**ADDENDUM #1
Allenspark Vault Toilet
Public Works
RFP # 7322-22**

Allenspark Vault Restroom Specifications (Addendum #1):

BOULDER COUNTY
ALLENSPARK TRANSFER SITE EXPANSION
VAULT RESTROOM

② VAULT RESTROOM CEILING PLAN
 1/2" = 1'-0"

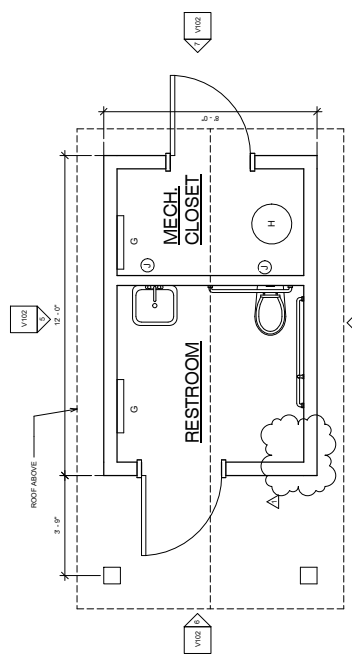
- i. Our quote included interior and exterior lights.

ANSWER: Interior and exterior lights are required see vault restroom ceiling plan on sheet V102.

- c. The Specifications seem to call for a flushing urinal. We included a waterless urinal before. A flushing urinal will result in a higher quote this time.

ANSWER: Revised plan (attached) shows that we have removed the urinal from the plan.
